Model: Cattleya 2		Date: 26-Feb-01	No.: RB023001
Subject: Main ROM upgrade for Cattleya2		Prepared by: H. Matsui	
From: Technical Services Dept., GTS Division			
Classification:	<input type="checkbox"/> Troubleshooting	<input type="checkbox"/> Part information	<input checked="" type="checkbox"/> Action required
	<input type="checkbox"/> Mechanical	<input type="checkbox"/> Electrical	<input type="checkbox"/> Service manual revision
	<input type="checkbox"/> Paper path	<input type="checkbox"/> Transmit/receive	<input type="checkbox"/> Retrofit information
	<input type="checkbox"/> Other ()

Model: Cattleya 2		Date: 24-May-01	No.: RB023003
Subject: Cattleya 2 Basic Tips		Prepared by: Tim. Okajima	
From: Technical Services Dept., GTS Division			
Classification:	<input checked="" type="checkbox"/> Troubleshooting	<input type="checkbox"/> Part information	<input type="checkbox"/> Action required
	<input type="checkbox"/> Mechanical	<input type="checkbox"/> Electrical	<input type="checkbox"/> Service manual revision
	<input type="checkbox"/> Paper path	<input type="checkbox"/> Transmit/receive	<input type="checkbox"/> Retrofit information
	<input type="checkbox"/> Other ()

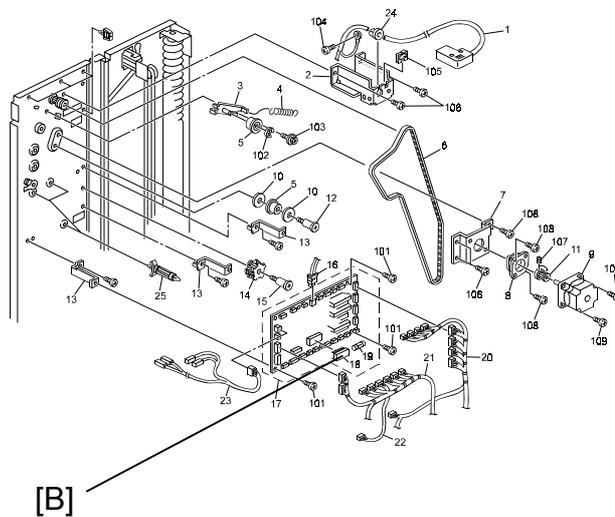
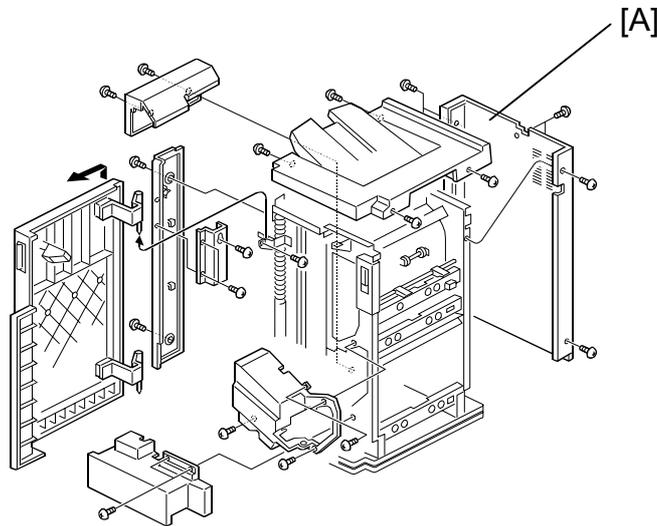
Service parts will be changed as follows:

S/S main board: A8315100 to A8315110 interchangeability: X/O

EPROM: A8315103 to A8135111 interchangeability: X/O

1. Remove the rear cover [A] (4 screws).
2. Replace the main ROM [B] with ver "G" or newer. The part number of this new main ROM is A8315111.
3. Confirm the ROM version with copier SP7-801-005. The last digit (for example G) indicates the ROM version.

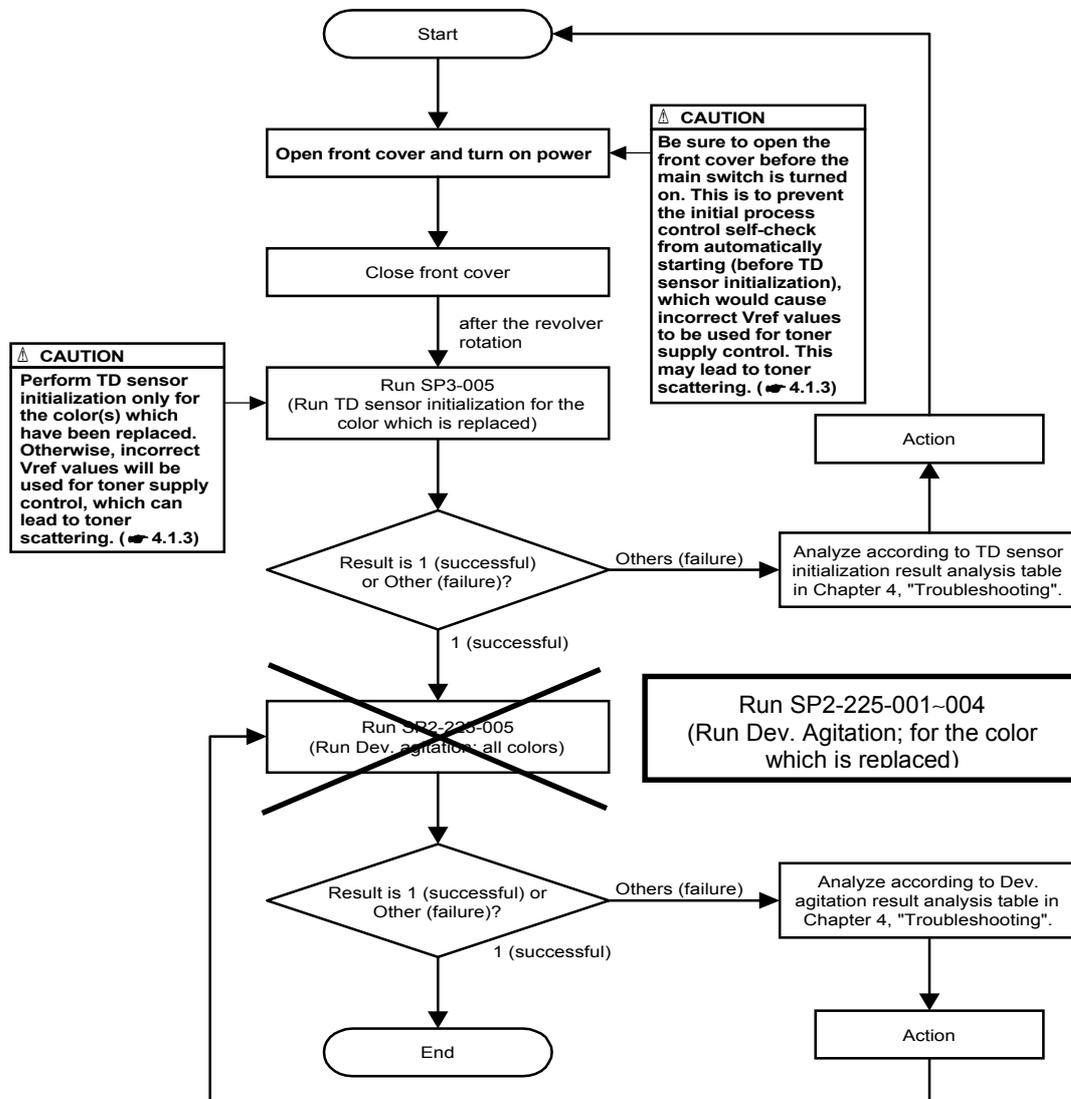
Please correct the Developer Initialization flow chart on page 3-55 as shown below (1 box).

This correction should only be applied to the Developer Initialization workflow for Developer Replacement on page 3-55. The flowchart for machine installation on page 1-19 should be left as is.

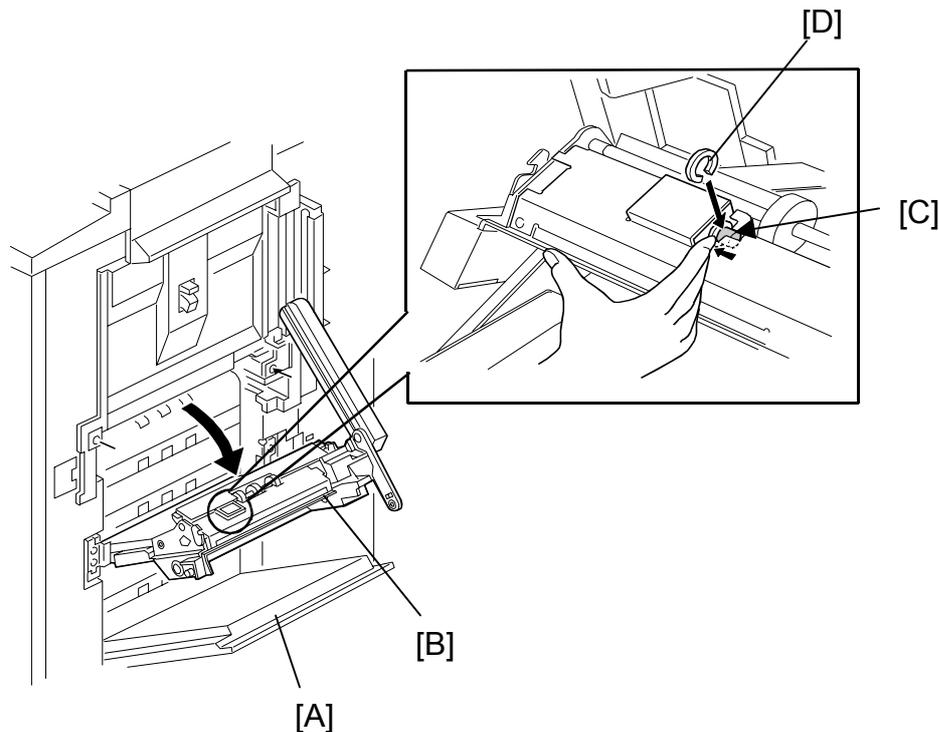
A by-pass feed jam may occur after repeated bypass feeds.

The plastic washer of the pick-up solenoid was missing, causing the plunger to be attracted in the opposite direction by its residual magnetic field and locked in place. The plastic washer normally prevents this attraction.

Add the plastic washer as follows.

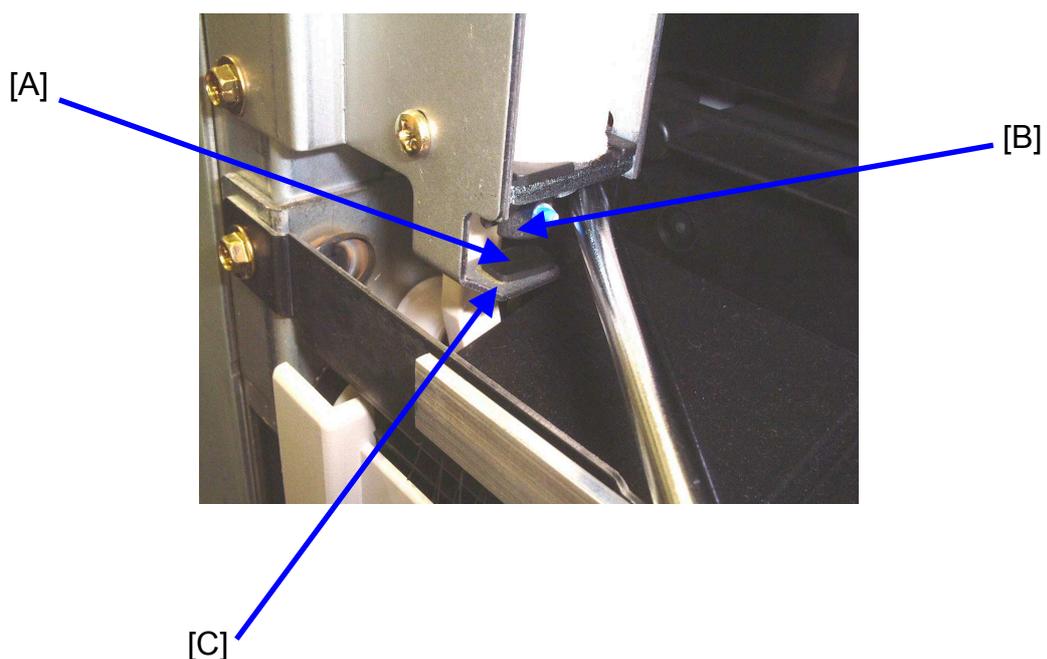
The duplex junction gate solenoid (AX120059) does not function correctly.

The shock-absorbent rubber plate [A] peels off the bracket (see the attached picture). After the plate comes off, the core of the solenoid [B] sticks to the solenoid bracket [C] (B0234463) because of magnetic attraction. Under this condition, the junction gate does not function correctly even though the solenoid is turned on.

Replace the solenoid bracket (B0234463), which includes the shock-absorbent rubber plate.

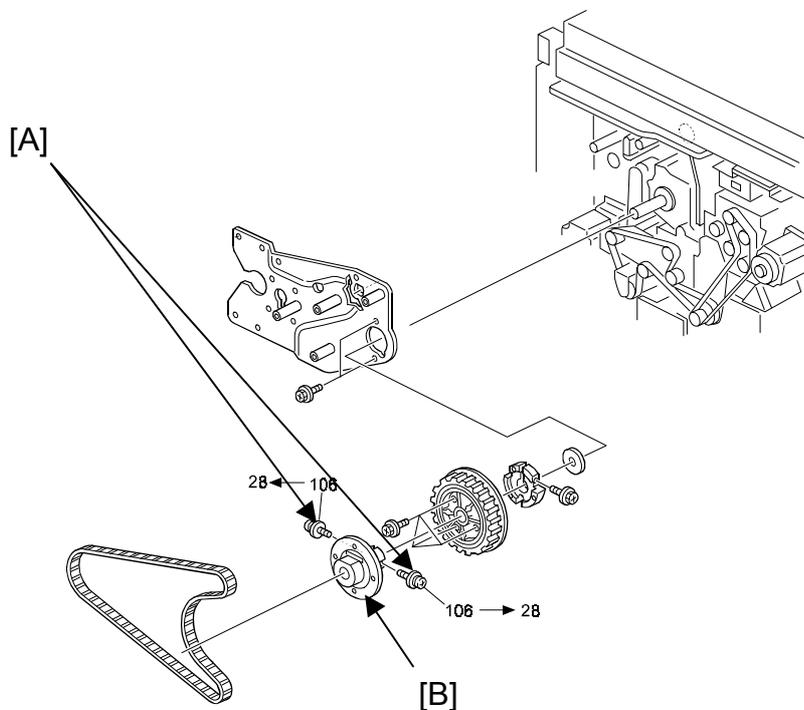
Abnormal noise from the drive section just after the Start Key is pressed or a print job is started.

The securing screws [A] for the Flywheel Supporter [B] come loose. If the machine is used under this condition, the Flywheel Supporter and screws will contact one another and generate noise. In some cases, this causes the screws to break.

At the next service visit, replace the Flywheel Supporter securing screws with the modified ones announced in MB023016 (P/N B0231100). The new screw is a double-pitch type to ensure that it remains properly fixed in place.

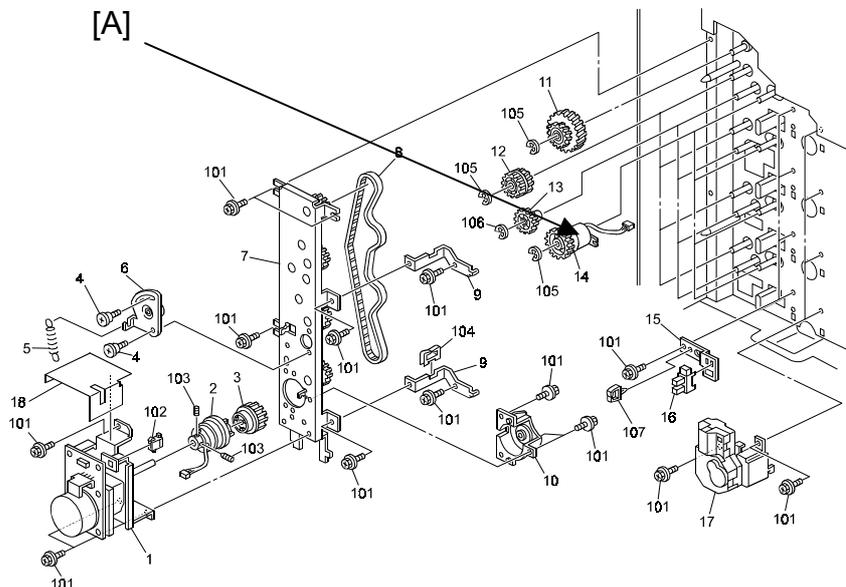
This has a tendency to occur just after installation.

For the magnetic clutch used in the machines, which were produced before the cut-in serial numbers described in the MB#MB023021, there is insufficient friction between the plates of the old type paper feed magnetic clutch [A] (AX200100), causing the plates to slip, even if the signal for magnetic engaging is being properly sent and received.

At first, apply the troubleshooting procedure written in RTB#RB023010 issued on September 6, 2001. If you cannot solve the problem with this procedure, replace the paper feed magnetic clutch with the modified new type (AX200245).

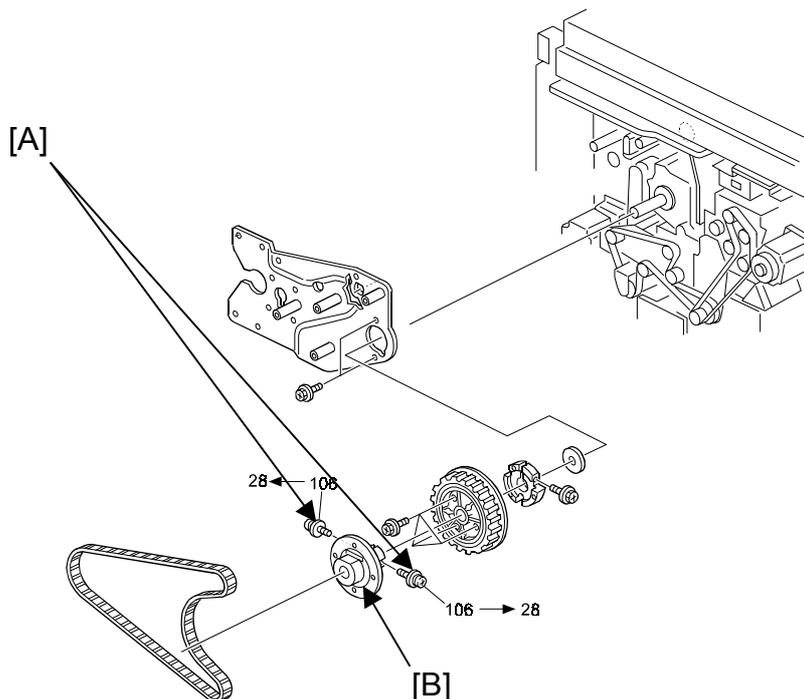
The securing screws [A] for the Flywheel Supporter [B] come loose. If the machine is used under this condition, the Flywheel Supporter and screws will contact one another and generate noise. In some cases, this causes the screws to break.

Replace the Flywheel Supporter securing screws at the next service visit with the modified ones announced in MB023016 (P/N B0231100). The new screw is a double-pitched type to ensure it stays properly fixed in place.

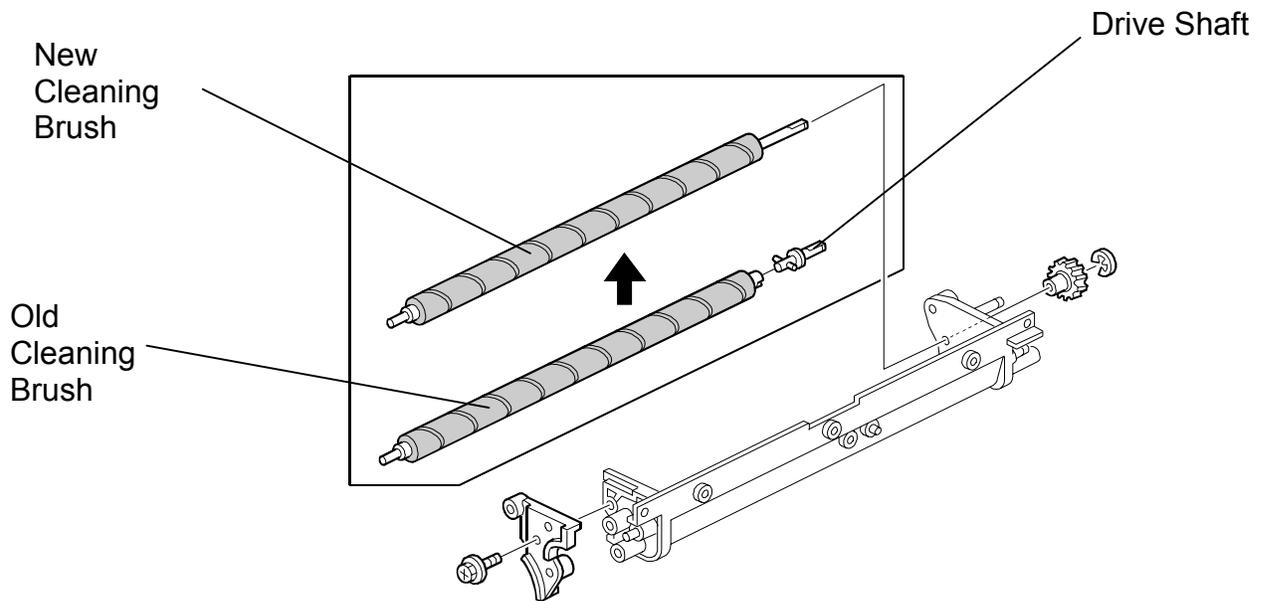
As announced in MB #MB023030, the Drum Cleaning Brush has been changed to include the Drive Shaft (illustration below). This RTB contains the PM replacement procedure of the Drum Cleaning Brush for the machine, whose S/N is before the cut-in S/N of this modification.

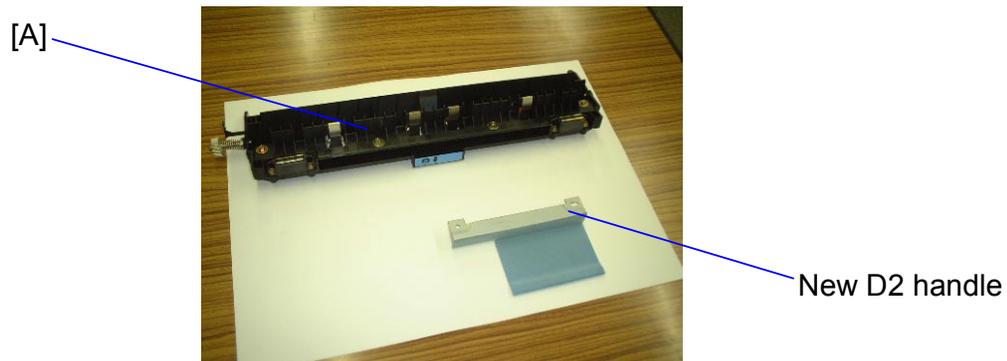
Since the current D2 handle on the fusing unit is difficult to find for some users, and its small size and shape make it difficult to overcome the magnetic lock, the handle has been enlarged and made more visible.

Attach the new D2 handle (P/N B0234157) to the fusing unit.

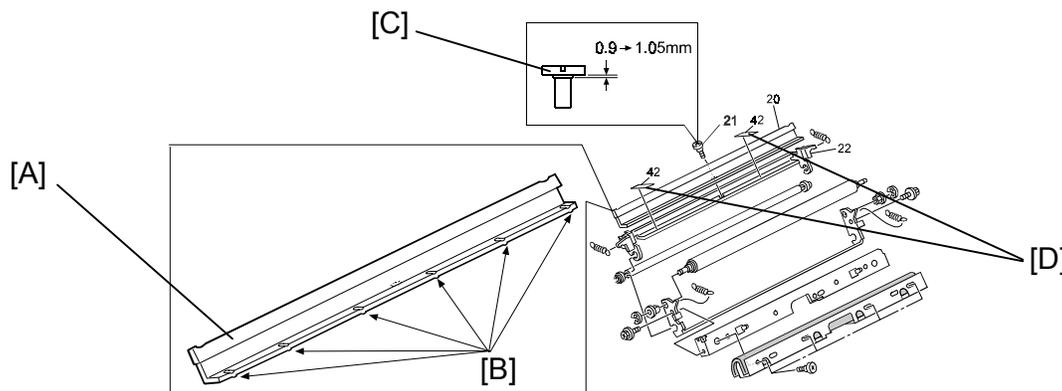
The pivoting movement of the Fusing Oil Blade (Parts Catalog, pg. 80, #20) is sometimes not uniform, allowing excessive oil to drop though the gap between the blade and Hot Roller. The oil then spills onto the copy surface or into the oil pan.

Replace the following parts as a set.

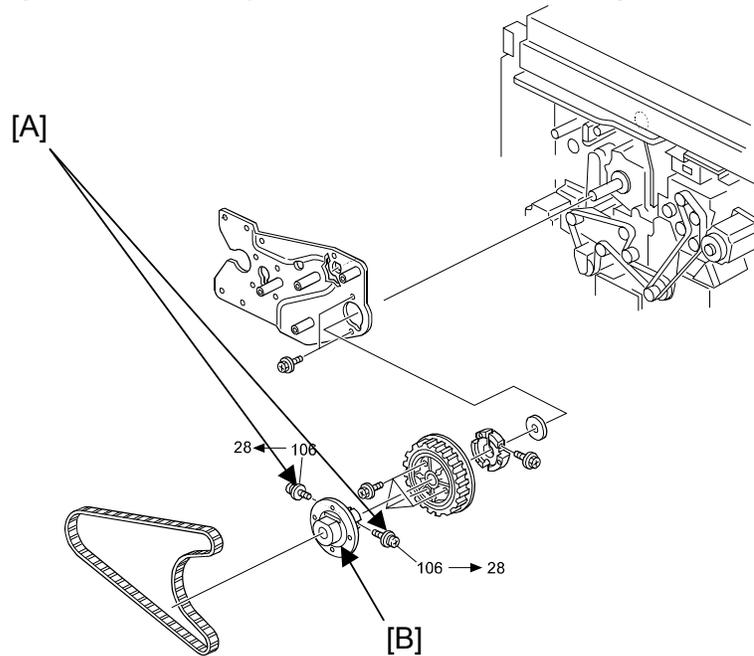
Even when the solution mentioned in RTB #RB023015a and MB #MB023016 is applied, noise is generated in the drive section just after the Start Key is pressed or a print job is started. If the machine is used under this condition, the flywheel supporter securing screws [A] come loose and break. The drum shaft then needs to be replaced, as the broken pieces of the screws can get inside.

New type

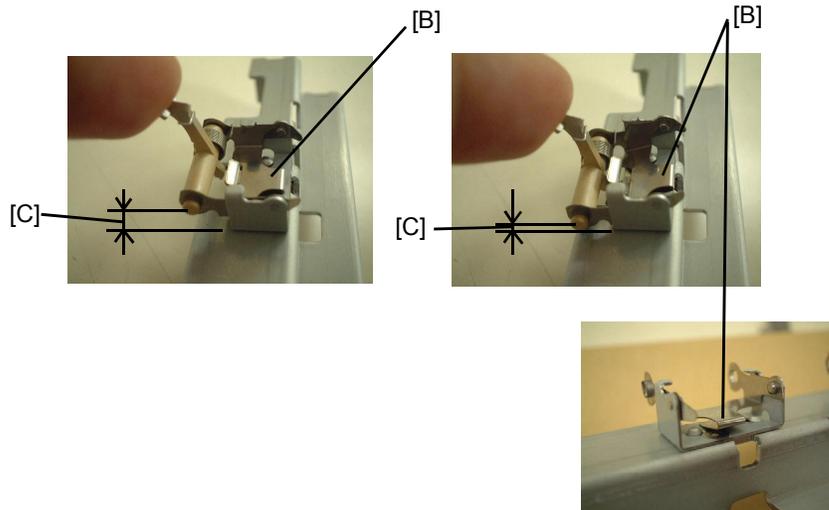
1. The stripper edge [A] has been widened, preventing damage to the hot roller from contact with this edge.
2. The stripper holder [B] has been newly designed as a plate-spring type, which allows the stripper to pull away from the roller when an accordion jam occurs. This ensures that the stripper will not damage the hot roller surface (max/min gaps shown by distance [C] below).

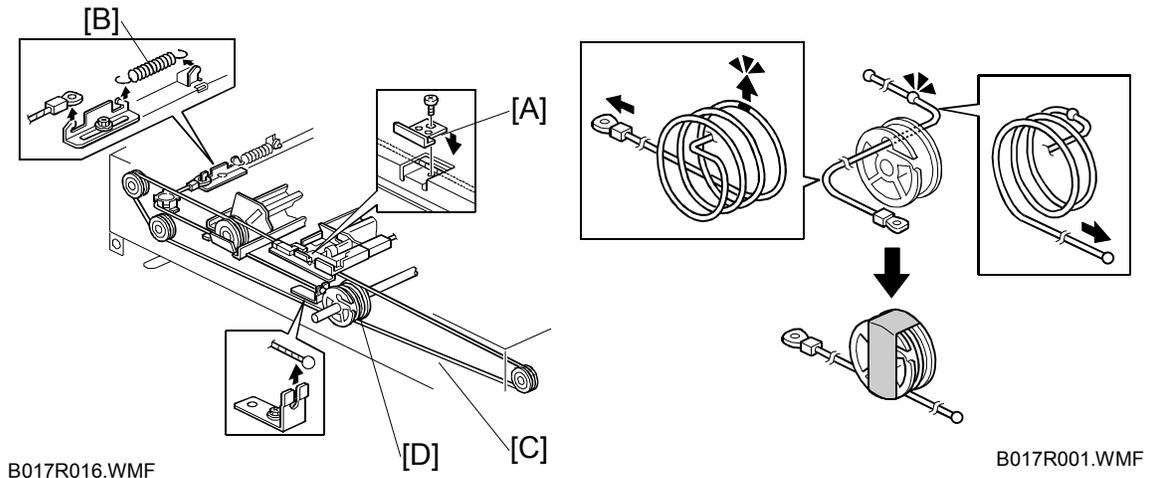
Please apply the following corrections to your Service Manuals.

P3-23 to 3-24: **Replace** with the following procedure (from Step 4).
